Errata to **2012 Edition** **National Electrical Safety Code®**

Correction Sheet
Issued 29 April 2013

Figure 234-4(b)—Clearance envelope for grain bins filled by portable augers, conveyors, or elevators

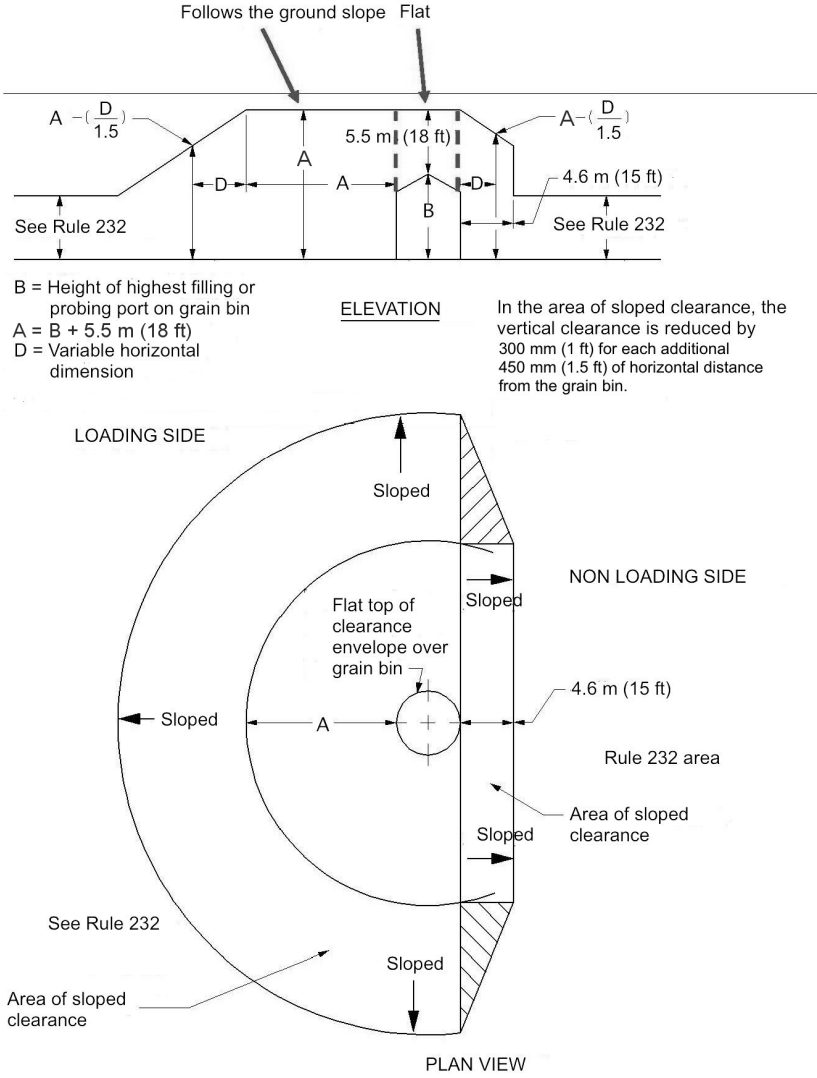
Page129: There are three errors in Figure 234-4(b). At the top of the figure, the two instances of “H” should read “A.” The text associated with “A” in the legend should read “B + 5.5 m (18 ft)” and not “V + 5.5 m (18 ft).”
